September 15, 1995  
NG-95-2236

Subject: Duane Arnold Energy Center  
Docket No: 50-331  
Op. License No: DPR-49  
Requests for Relief from ASME Section XI Requirements:  
NDE-012 through NDE-018

DUANE ARNOLD ENERGY CENTER  
2<sup>ND</sup> 10-YEAR INTERVAL  
REQUEST FOR RELIEF NO. NDE-012

HEA-CC-08 (1 through 4) Residual Heat Removal (RHR) Heat Exchanger Integral Attachment Welds

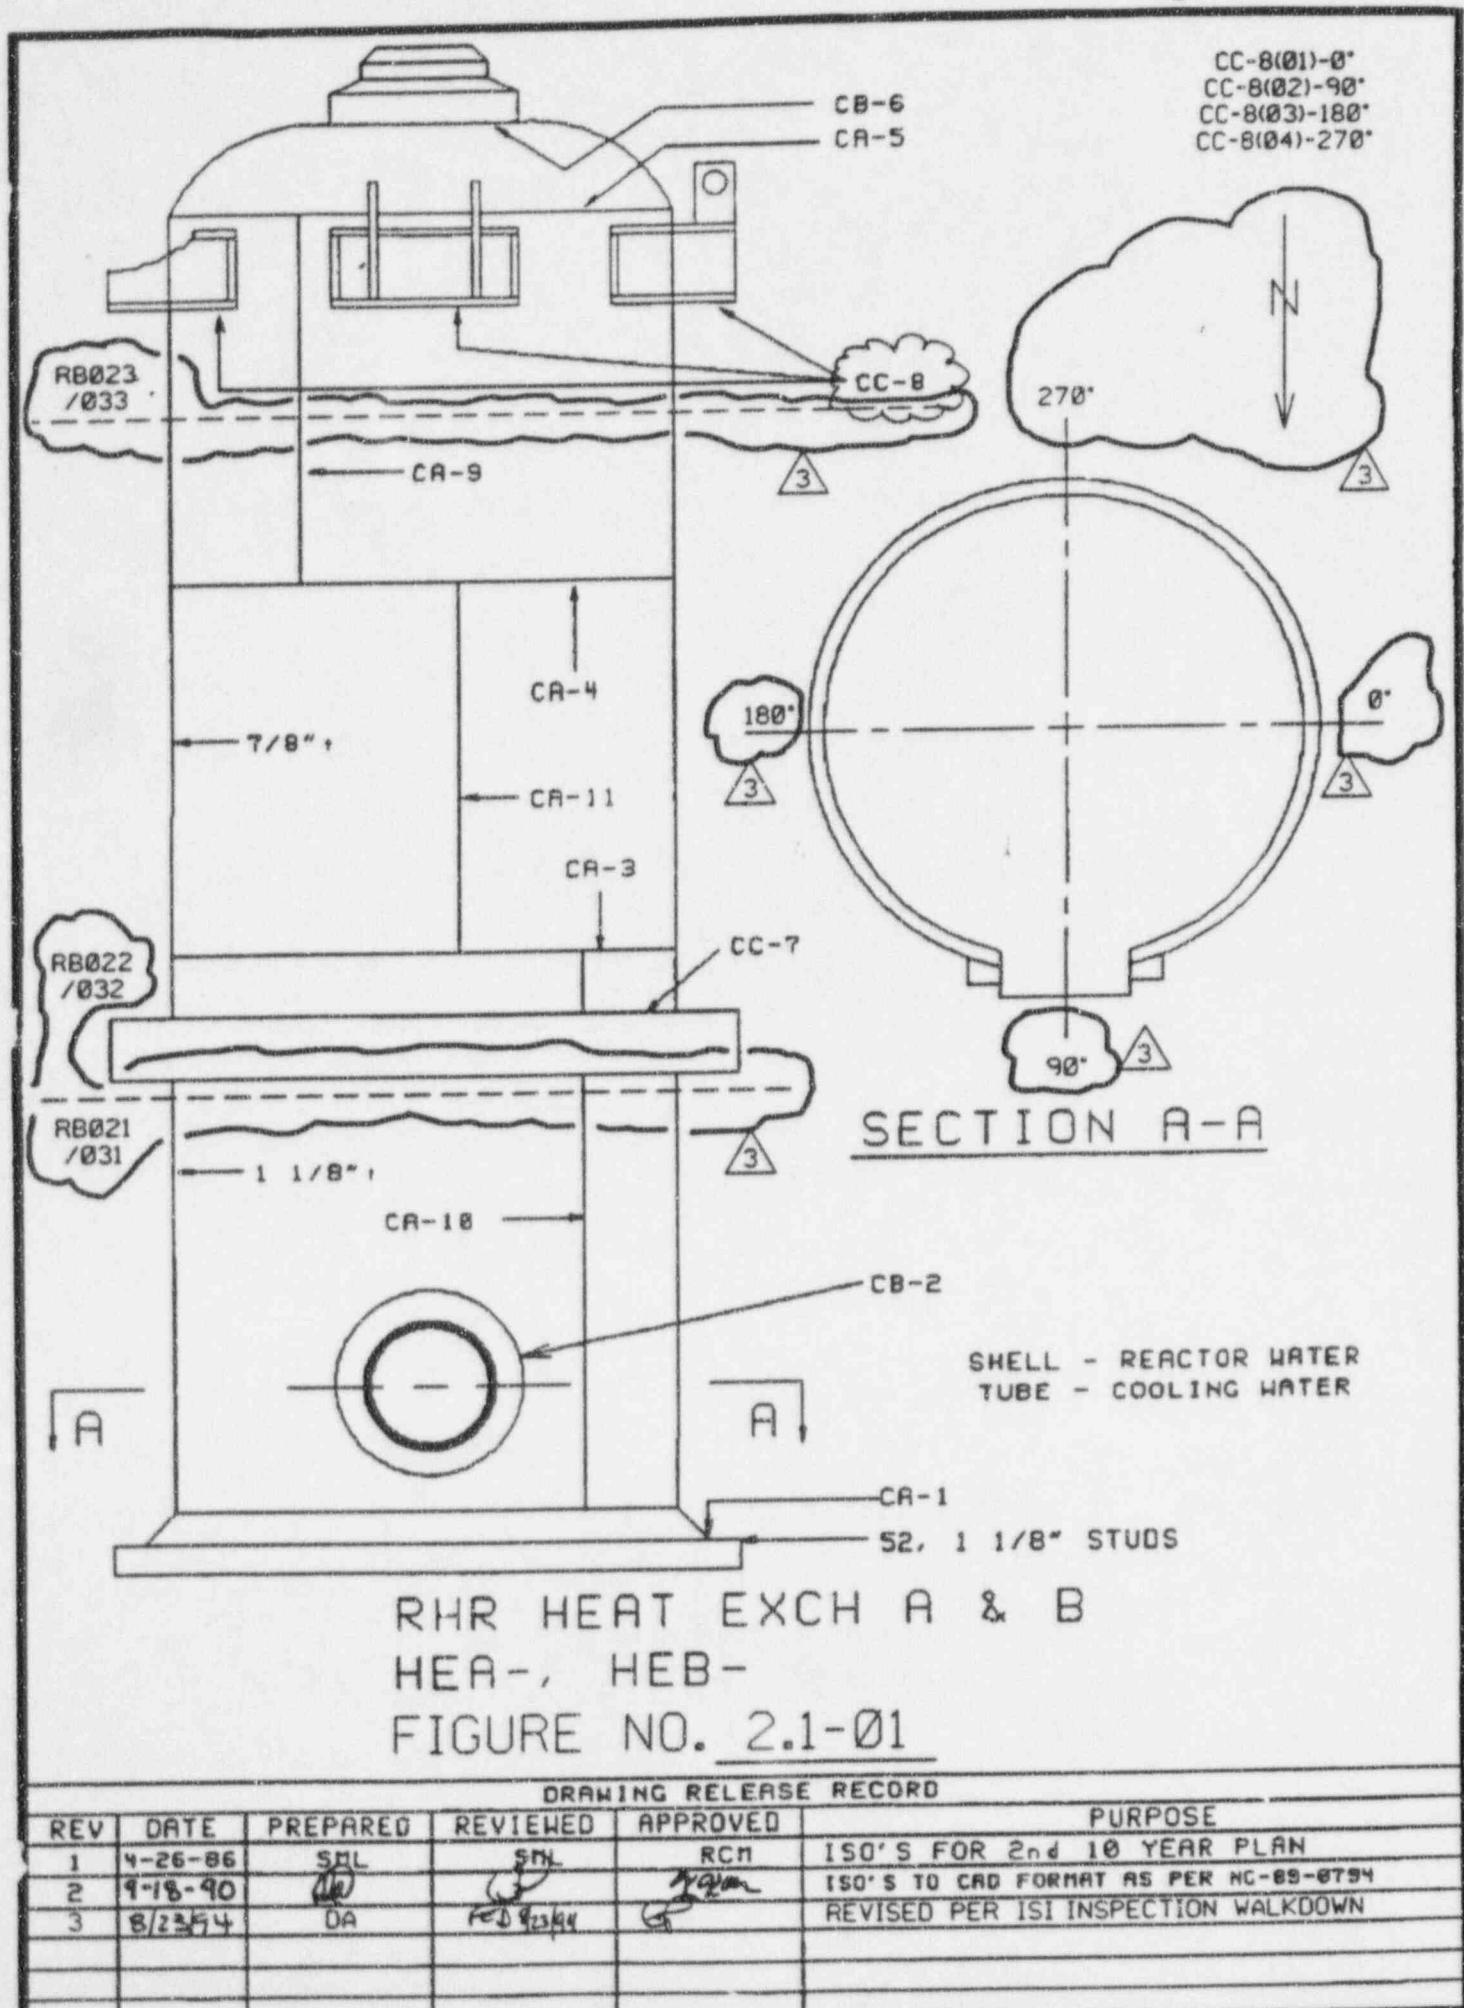
Relief is requested from performing essentially 100% of the weld length for HEA-CC-08 (1 through 4).

The design of the support does not allow access to the entire length of weld as required for the code examination. In order to perform the surface examination of the inaccessible portion of 14" on each support, the RHR heat exchanger would be required to be supported by alternate supports while the bolts were removed to allow access for the examination. The dose rates in this area are 50 to 70 mr/hr. Examining the 14" of weld for each support has only a small potential for increasing plant safety margins and a very disproportionate impact on expenditures of plant manpower and radiation exposure.

IES Utilities Inc. proposes to perform a surface examination of the accessible 82.5% of the weld length for each of the four welds (HEA-CC-08, 1 through 4). The examination coverage specified in Code Case N-460 will be utilized.

RBA-J007 Recirculation Bypass weld

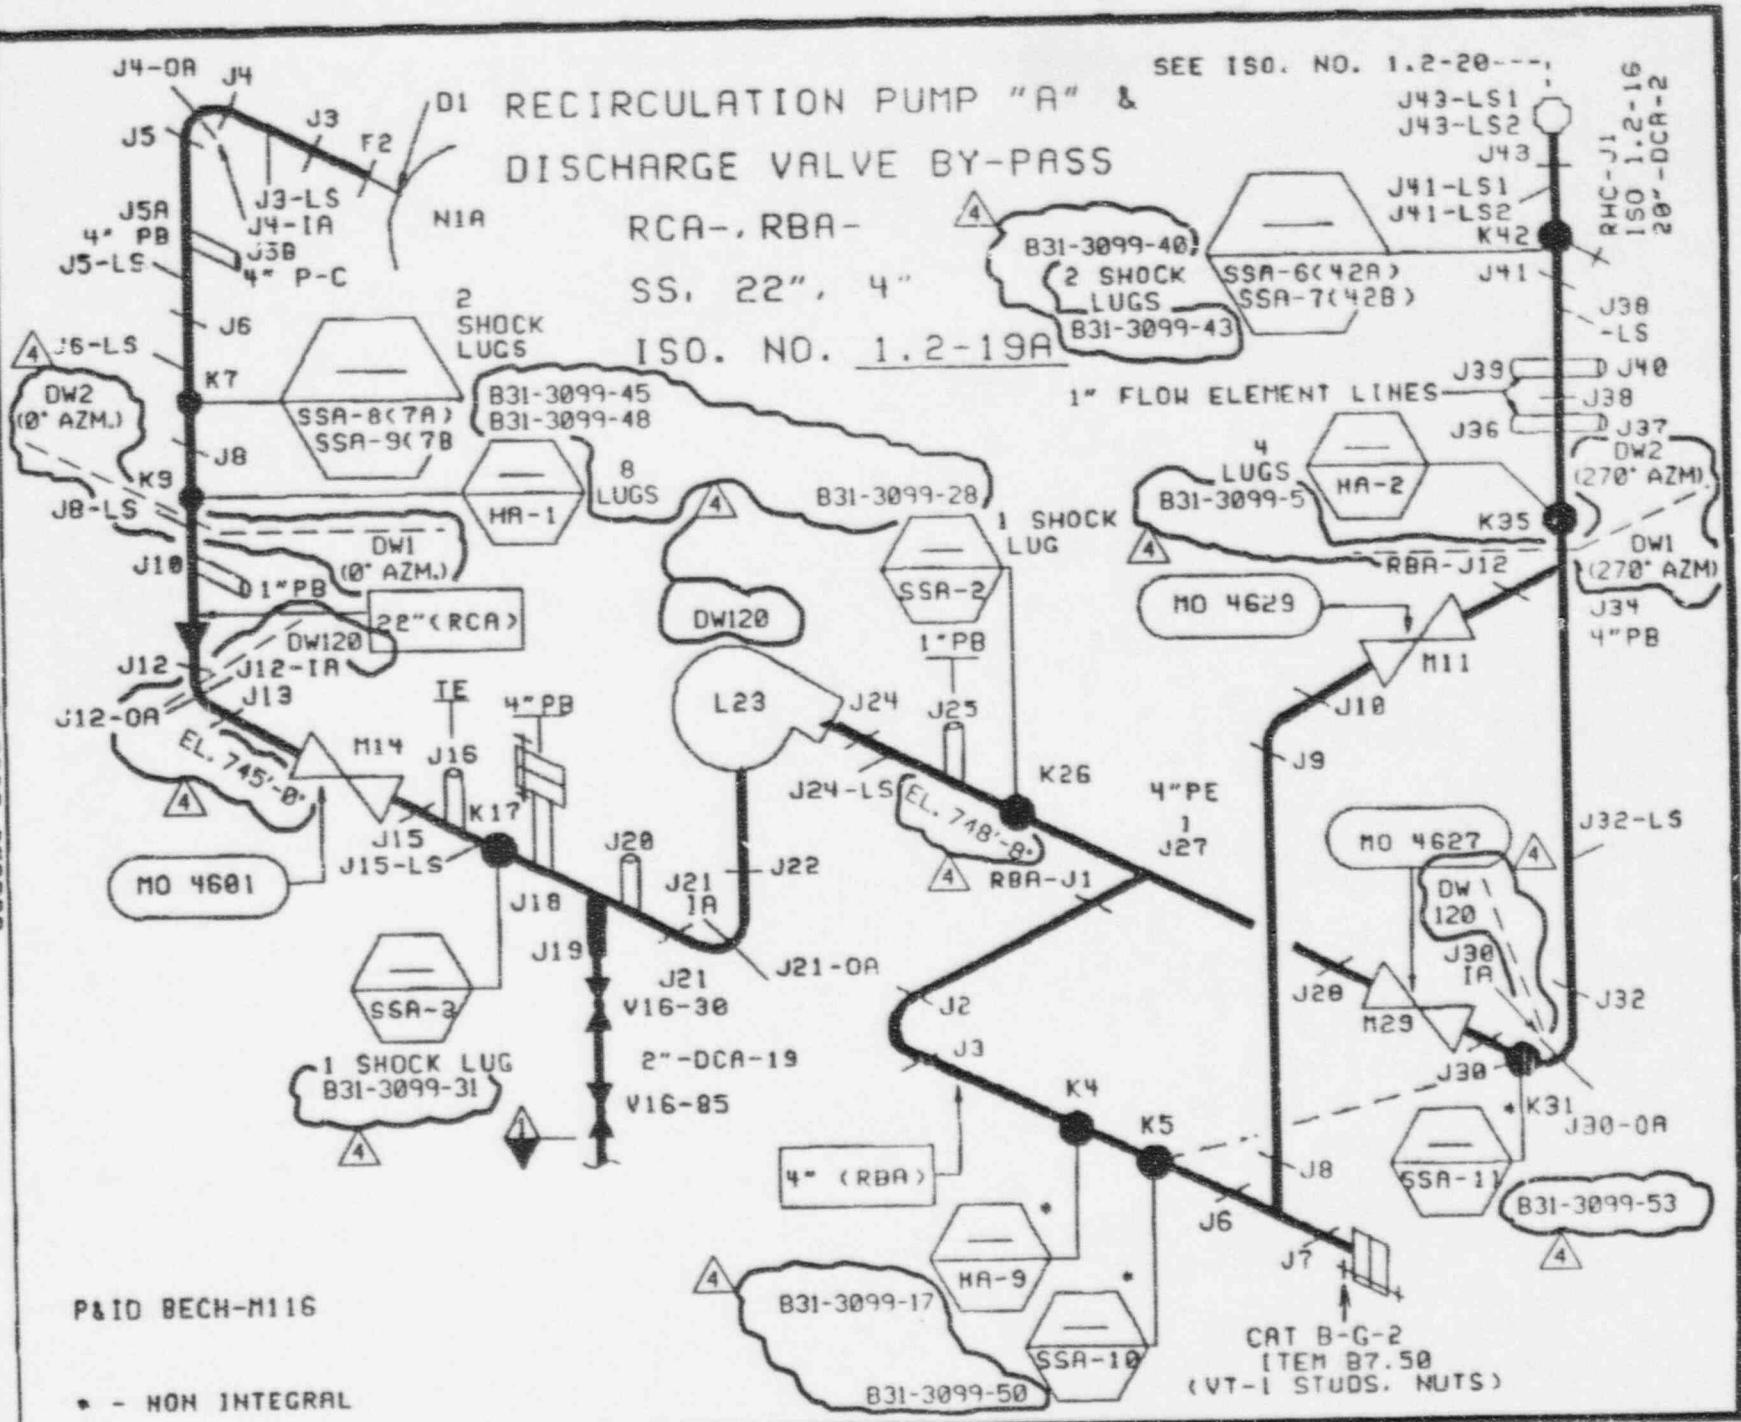
Relief is requested from performing essentially 100% of the weld length for Recirculation Bypass Weld RBA-J007.

The weld is a tee-to-flange configuration which limits the volumetric (UT) examination to a one-sided exam from the tee side. In addition, the tee configuration limits the one-side examination to 85% of the weld length. In order to perform a radiograph of the weld, the recirculation system would be required to be drained, thus increasing exposure to personnel by a factor of 1.7 (50 mr/hr vs 29 mr/hr) for a total of 120 mr for the additional 15% coverage. This is the additional exposure for the examination, installation and removal of insulation and shielding; it does not include any additional exposure resulting from the time spent performing valve line-ups or system draining. Examining the additional 15% of weld length has only a small potential for increasing plant safety margins and a very disproportionate impact on expenditures of plant manpower and radiation exposure to perform the radiography.

IES Utilities Inc. proposes to perform volumetric examination of the accessible weld, obtaining a total of 85% coverage for this weld length. The examination coverage specified in Code Case N-460 will be utilized.

RBA-J012 Recirculation Bypass Weld

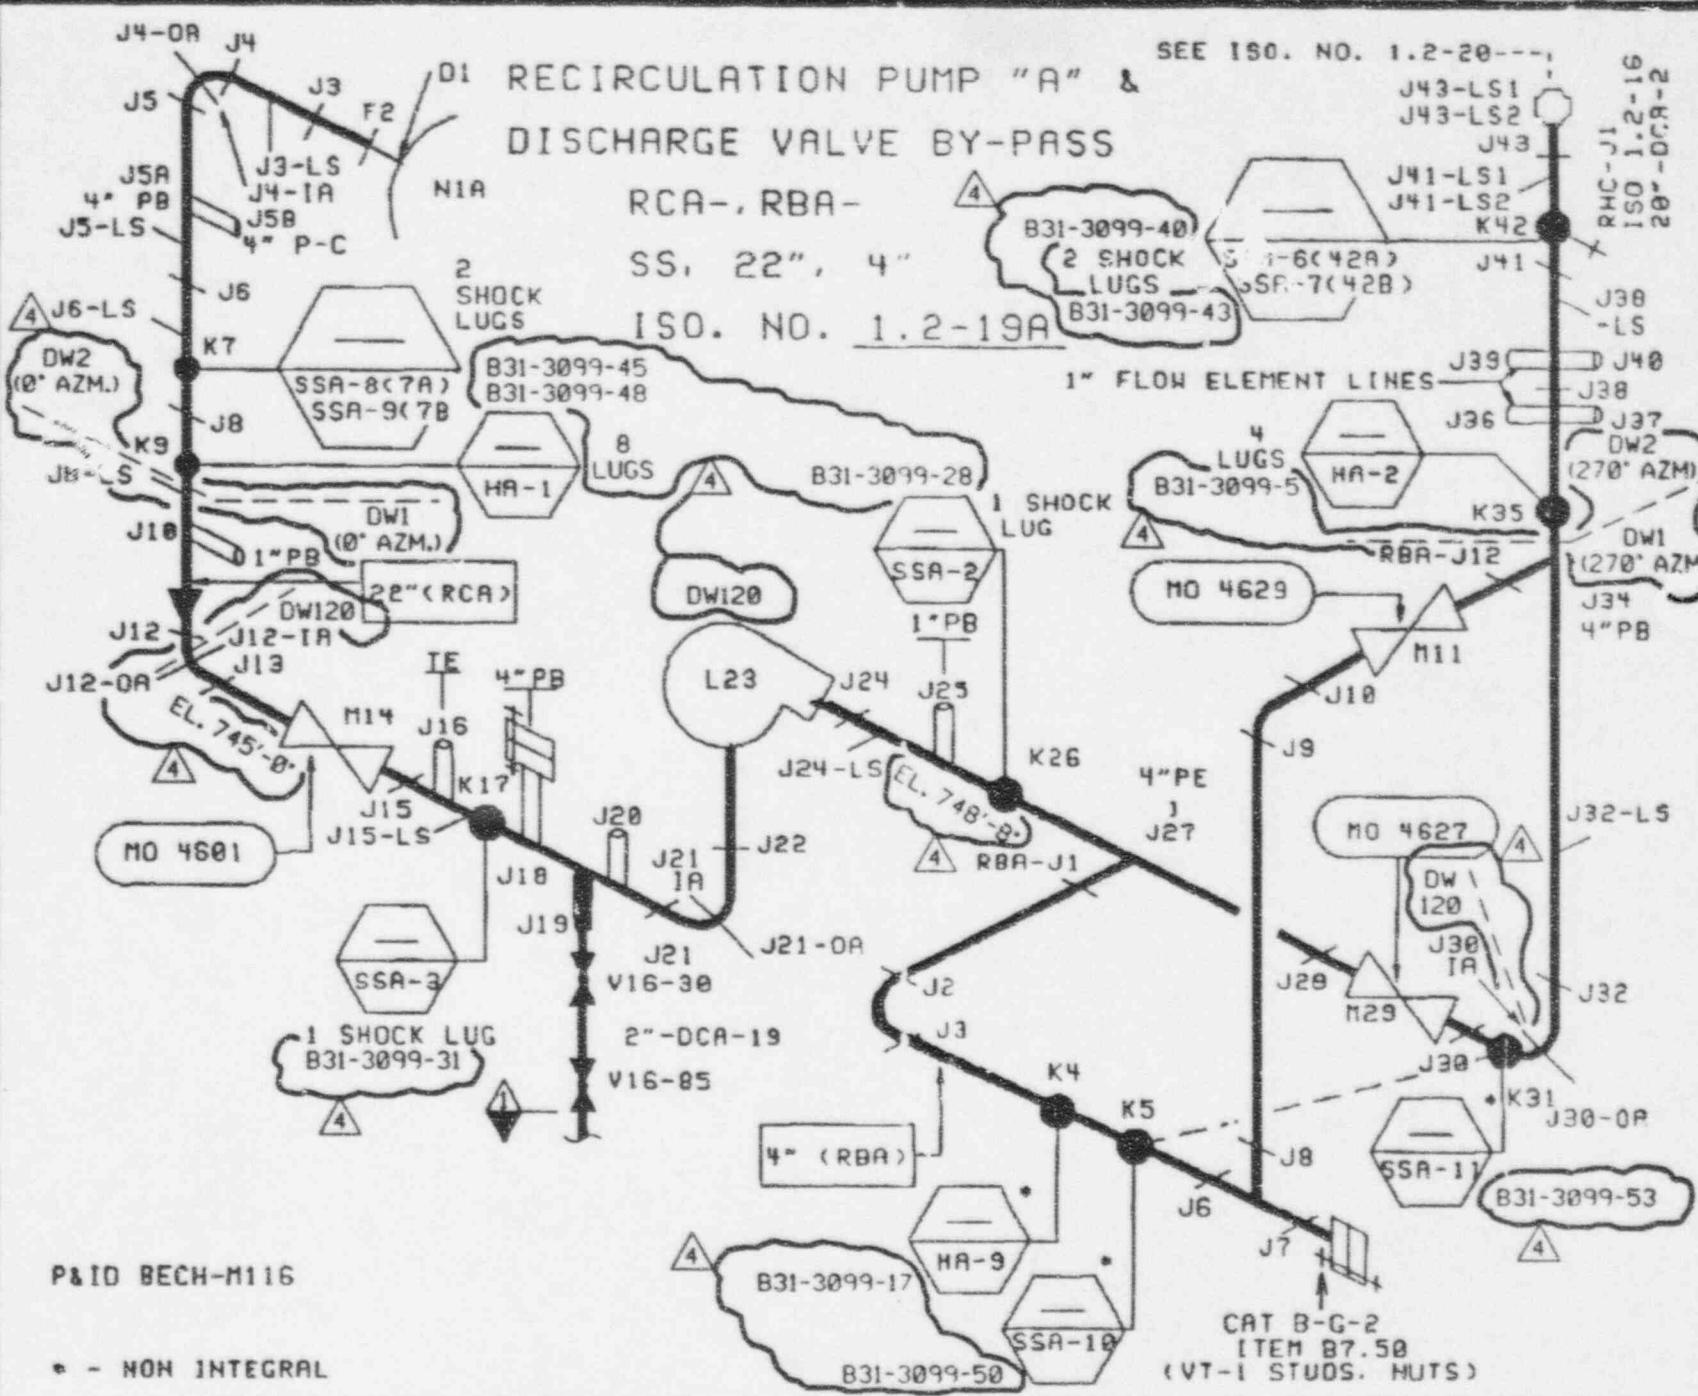
Relief is requested from performing essentially 100% of the weld length for Recirculation Bypass Weld RBA-J012.

This weld is a valve-to-weldolet configuration which limits the volumetric examination coverage to 76% of the weld length. In order to perform a radiograph of the weld, the recirculation system would be required to be drained, thus increasing exposure to personnel by a factor of 1.7 (50 mr/hr vs 29 mr/hr) for a total of 435 mr for the additional 24% coverage. This is the additional exposure for the examination, installation and removal of insulation and shielding; it does not include any additional exposure resulting from the time spent performing valve line-ups or system draining. Examining the additional 24% of weld length has only a small potential for increasing plant safety margins and a very disproportionate impact on expenditures of plant manpower and radiation exposure to perform the radiography.

IES Utilities Inc. proposes to perform volumetric examination utilizing the required 45° shear supplemented with a 70° Refracted Longitudinal exam of the accessible weld, obtaining a total of 76% coverage for this weld. The alternative examination coverage specified in Code Case N-460 will be utilized.

CUB-F004 Reactor Water Cleanup (RWCU) Weld

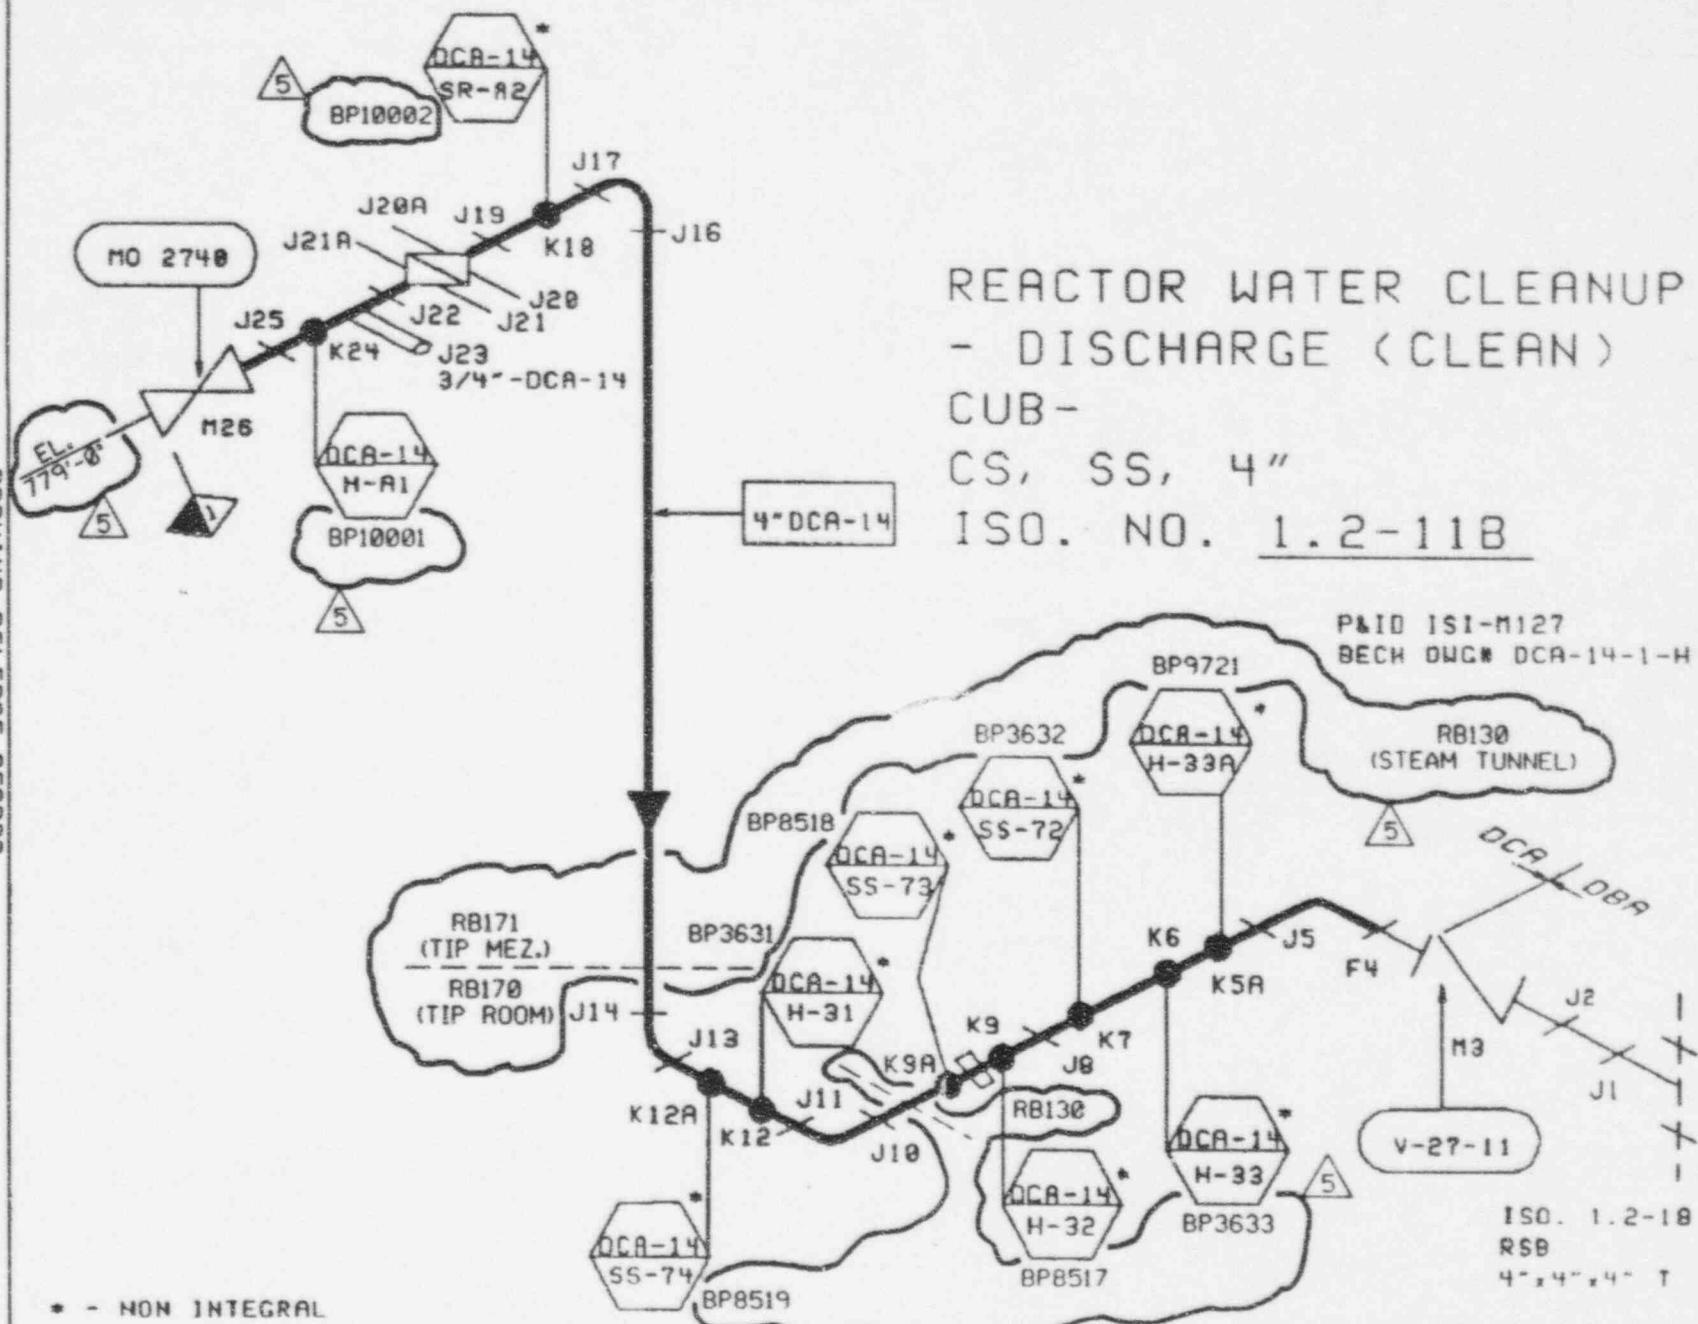
Relief is requested from performing essentially 100% of the weld length for RWCU Weld CUB-F004.

This weld is a elbow-to-valve configuration which limits the volumetric (UT) coverage to a one-sided exam. This results in approximately 70% coverage of the weld length. In order to perform a radiograph of the weld, the RWCU System would be required to be drained, which would result in an increase in exposure to personnel by a factor of 1.7 (17 mr/hr vs 10 mr/hr) for a total of 70 mr for the additional 30% coverage. This is the additional exposure for the examination, installation and removal of insulation and shielding; it does not include any additional exposure resulting from the time spent performing valve line-ups or system draining. Examining the additional 30% of weld length has only a small potential of increasing plant safety margins and a very disproportionate impact on expenditures of plant manpower and radiation exposure.

IES Utilities Inc. proposes to perform volumetric examination of the 70% weld length. The alternative examination coverage allowed by Code Case N-460 will also be used.
